STAFF REPORT: 02-10-2021 MEETING

APPLICATION NUMBER: 21-7055

ADDRESS: 3960 THIRD

SCOPE: ALTERATION TO PREVIOUSLY APPROVED STOREFRONT, DOORS AND WINDOWS

Original approval

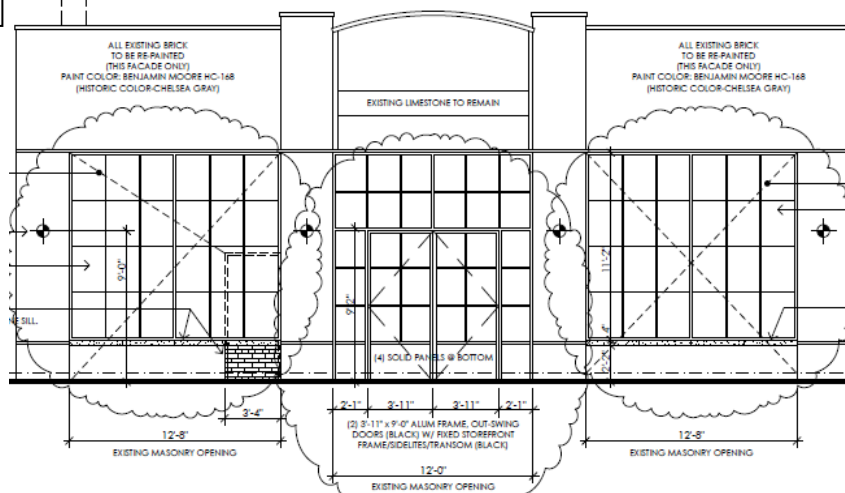
- **Color Change:** The applicant proposes to repaint the elevation Benjamin Moore, Raven, which is close to B:19 – Black. *Previously approved color was Benjamin Moore, Chelsea Gray, which is close to B:10 - Grayish Green and is still listed on the current elevation.*

- **Storefront Alteration:** The brick in the two openings (as seen in the 2019 photograph) has been removed, per the approval given in the original application.
Selected storefront system: Kawneer 451 & 451T (Thermal) Framing System; Selected Entry System: Kawneer, 190 Narrow Style Entrance. Color: black.

- The right and left openings will be identical in design with fixed aluminum storefront frames, insulated fixed glass and central mullions. Each opening will be six glass panels wide and four glass panels high. *Previous approval included storefront system with folding windows below fixed glass panels (right opening); and folding and fixed panel storefront system/entry door below fixed glass panels (left opening).*

- The existing limestone sills will be replaced with new 4" limestone sills (to match existing). Brick veneer will remain below the sills.
 - The center opening will contain two out-swing doors (each 3'-11" x 9'-0" aluminum frame will have two glass panels wide and three glass panels high with solid bottom panel, color: black). Sidelights (one panel wide and four panels high - solid bottom panel and three glass panels) and transom (six glass panels wide and two glass panels high) with central mullion will fill the remaining opening. *Previous approval included a new aluminum and glass garage door.*

- Four swan neck lighting fixtures (indicated by circles) will be installed, color: black.

- The proposed storefront installation is minimal in design, sympathetic to a general storefront typology, and is compatible with the building's massing, scale and remaining architectural features.
- The solid panels specified for the bottom of the entrance doors and storefront system within the central opening closely align with the sill height of the adjacent openings. This detail creates a cohesion between the three openings on the symmetrical façade.

- The profile and dimensions of the muntins of the storefront system and entry system are not clearly described or shown within the submitted catalog cuts.

East/Rear Elevation

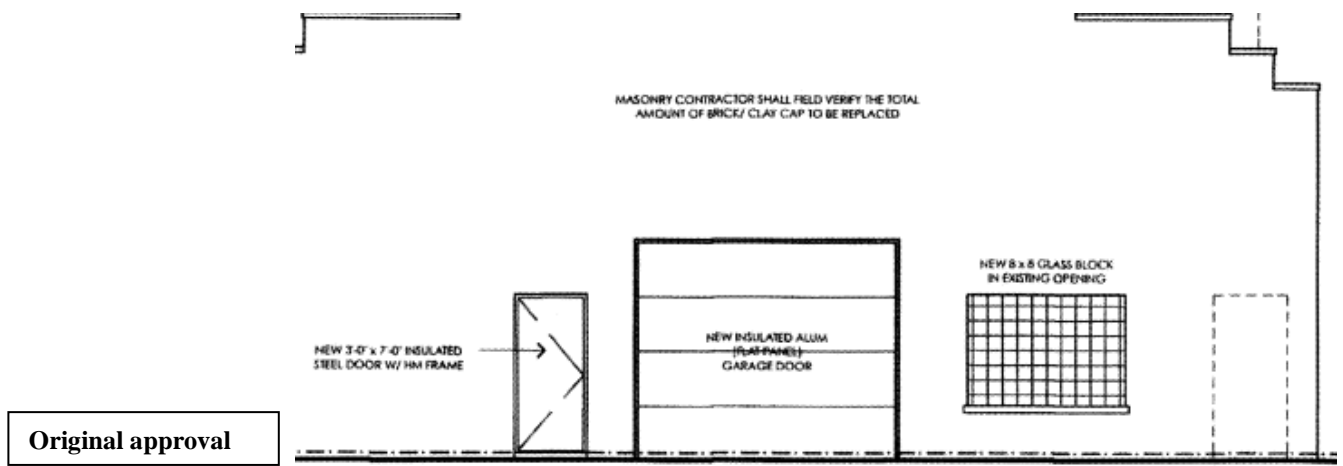
- The north window opening will remain bricked/blocked in as it currently exists. *Previous approval specified glass block to fill the existing opening.*

- The south opening that has brick and concrete block will be replaced with brick. The existing, non-original pedestrian door will be bricked in to match the existing wall surface. *Previous approval proposed the brick and concrete block to remain, and a new pedestrian door.*

- The currently existing rolling garage door opening will be partially filled with a wall and will also include a small roll-up/coil door and pedestrian door (3'-0" x 7'-0" insulated egress door, solid and smooth aluminum face). The wall and pedestrian door surfaces will be faced with metal siding. Material: ATAS Rigid Wall, smooth surface, color: black. According to the submitted product literature, the panels are 15/16" deep and have 1-5'8" wide ribs. The fastening system offers uninterrupted vertical or horizontal sight lines; this application will be installed horizontally. *Previous approval included a new insulated aluminum overhead garage door.*

- The Thermisor rolling door will have flat slats and be black in color.
- Two wall-mounted LED light fixtures will be installed on the rear elevation.

- As this elevation faces an alley and has suffered from deferred maintenance and multiple enclosures, the new pedestrian door and roll-up door will not likely replace any historic materials, nor impact any character-defining features.
- The elevation drawing gives the effect of uniformity in surface finishes for the central opening, however the new coiling door will have flat slats, while the rigid wall system will have a dimensional horizontal pattern.
- It is staff's opinion the rear elevation shows many unsympathetic alterations have occurred. The current proposal to uniformly brick-in the south opening (which is now concrete block and brick) and to retain the brick within the north opening will lessen the disjointed appearance of this elevation while retaining evidence of the previous openings.

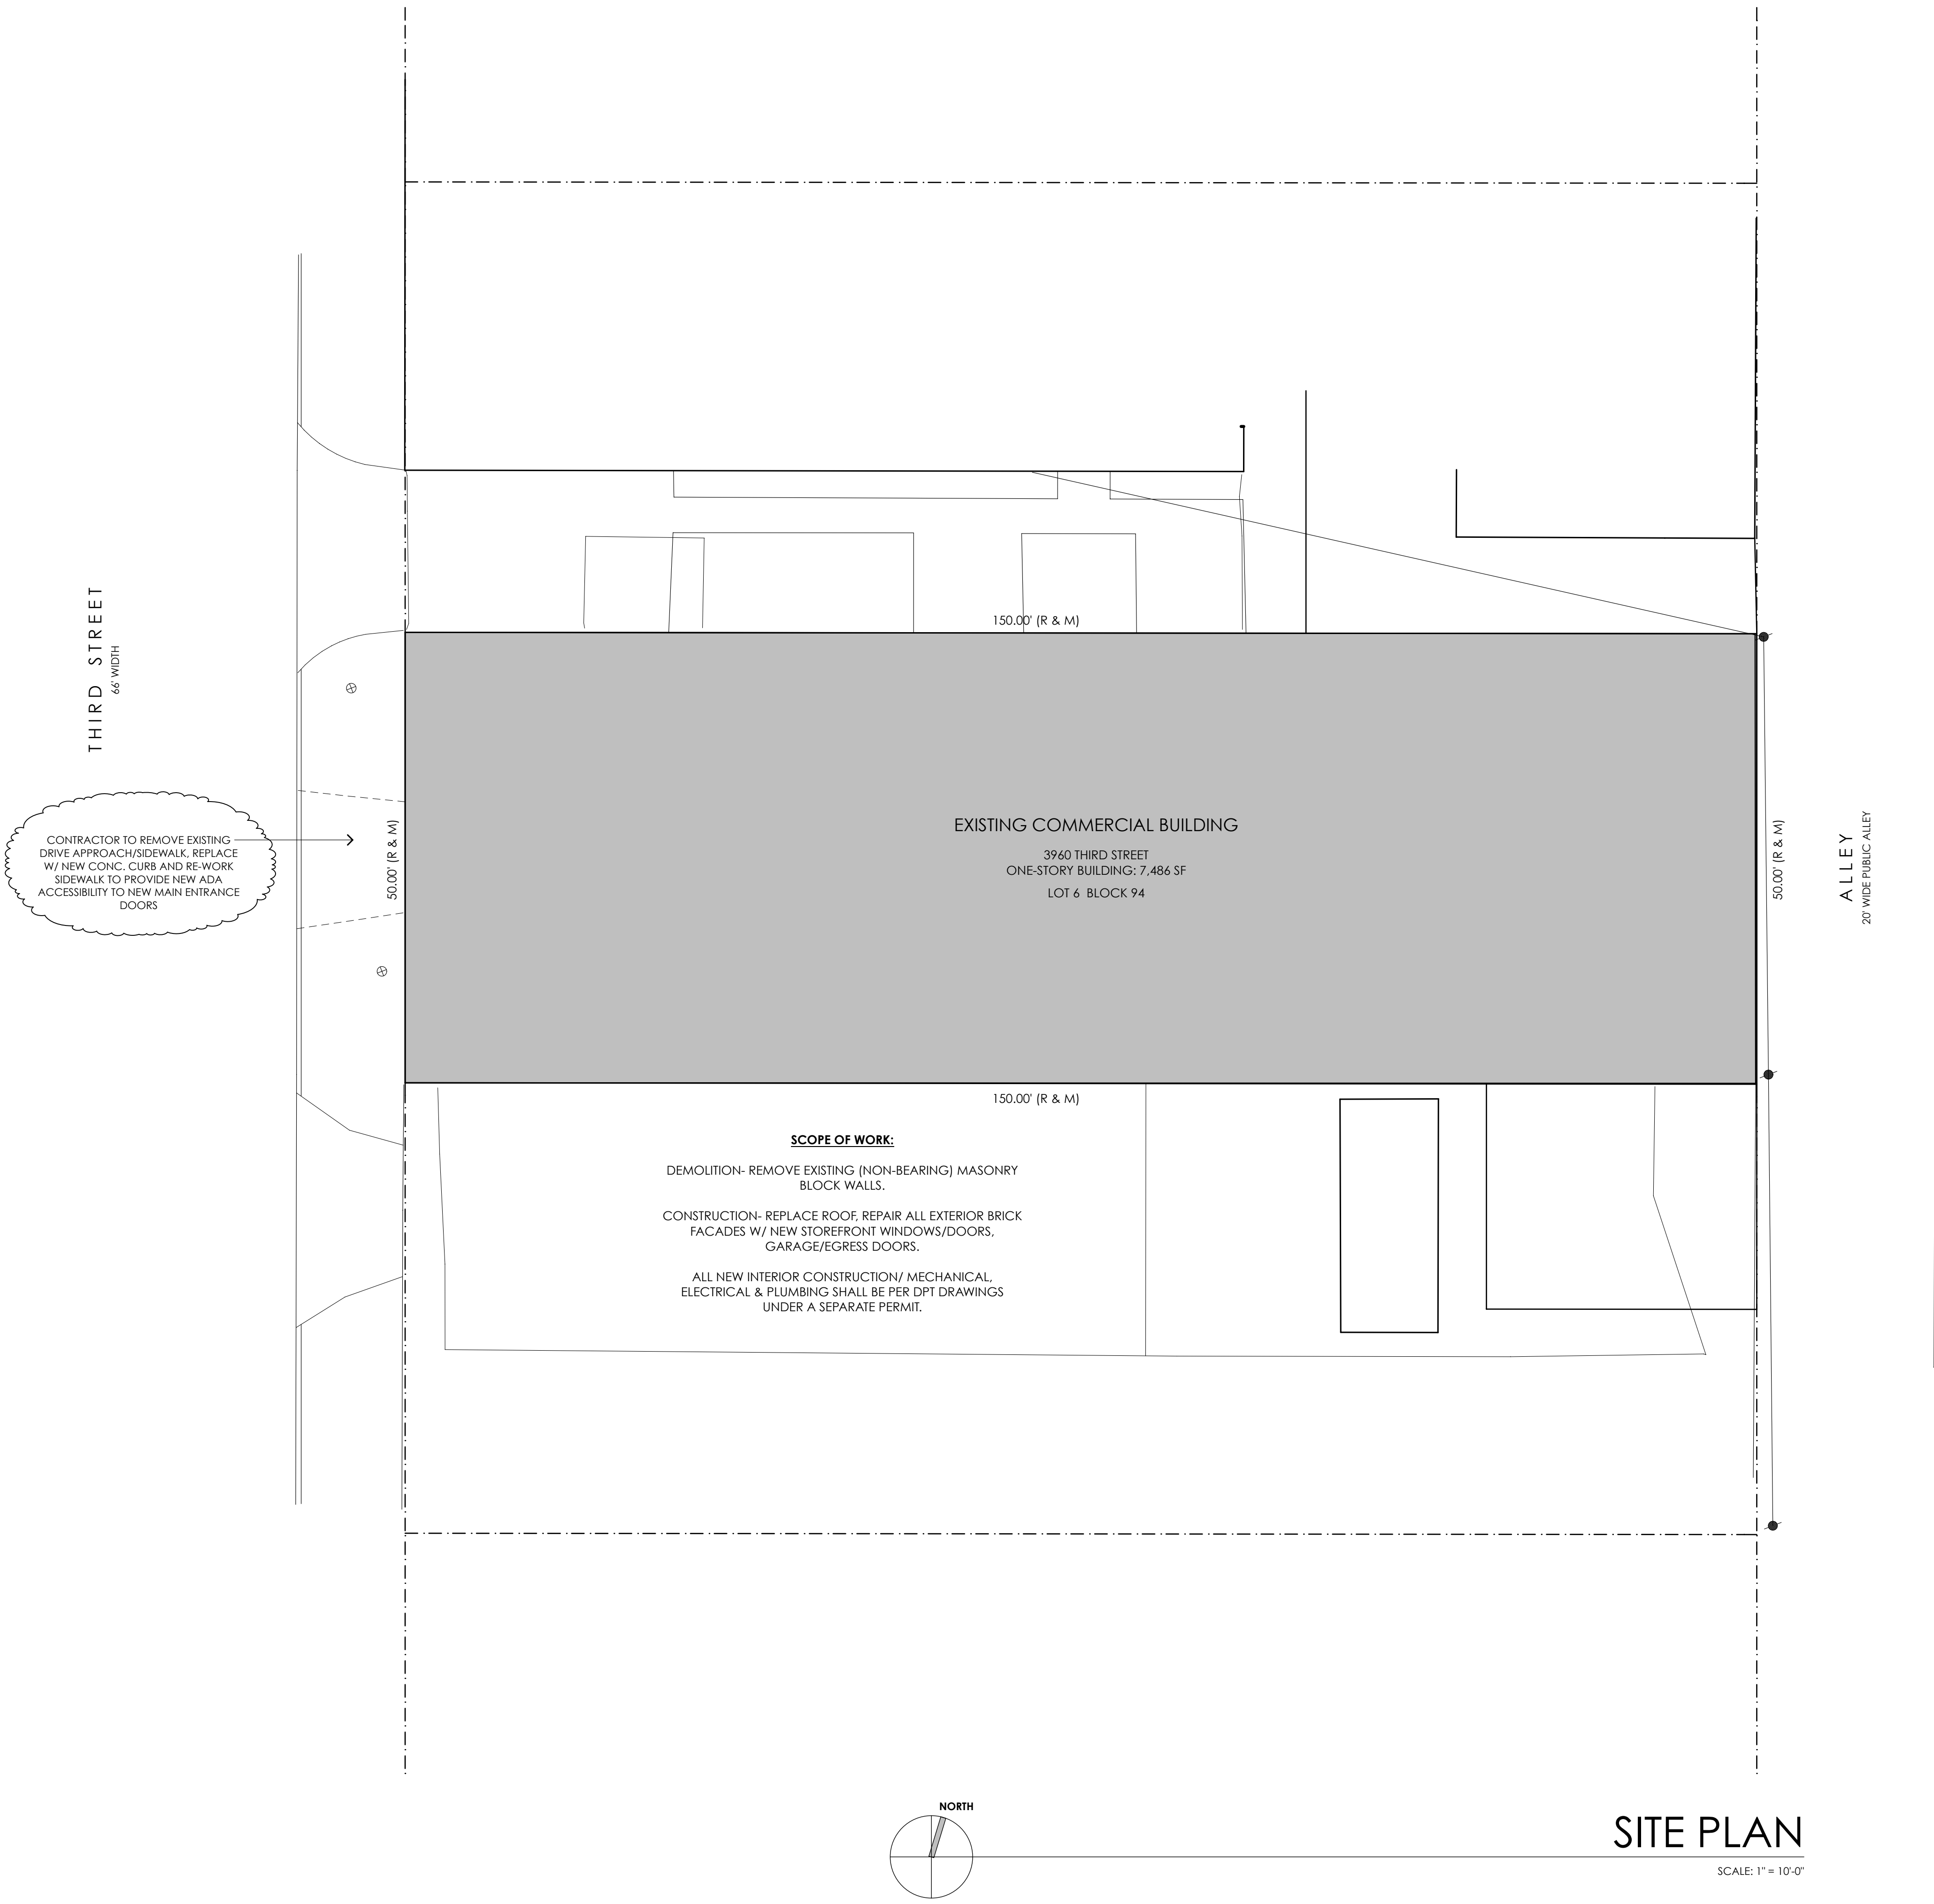
Fill in this door to match existing wall surface

Retain opening- install metal overhead door, wall surface and pedestrian door – both to be sided to match metal overhead door and read as one large overhead door

WEST ELEVATION

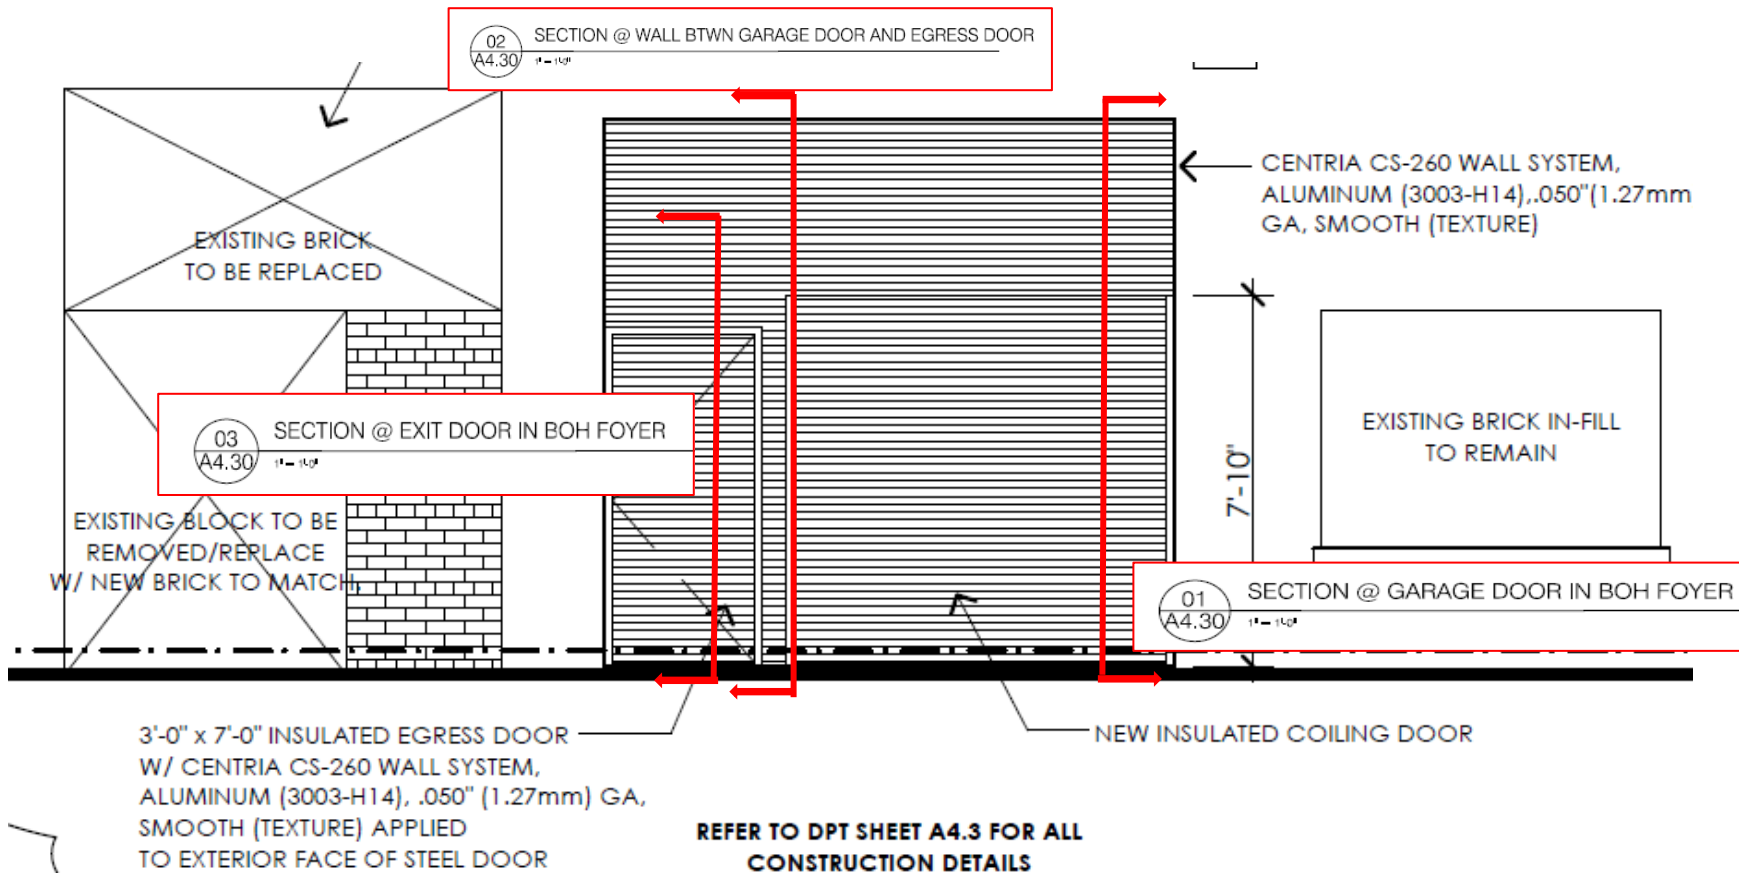
- The elevations call out the Centria wall system, however the second page of the data sheets say the ATAS Rigid Wall System will be used. The drawings should be revised to state the selected system.
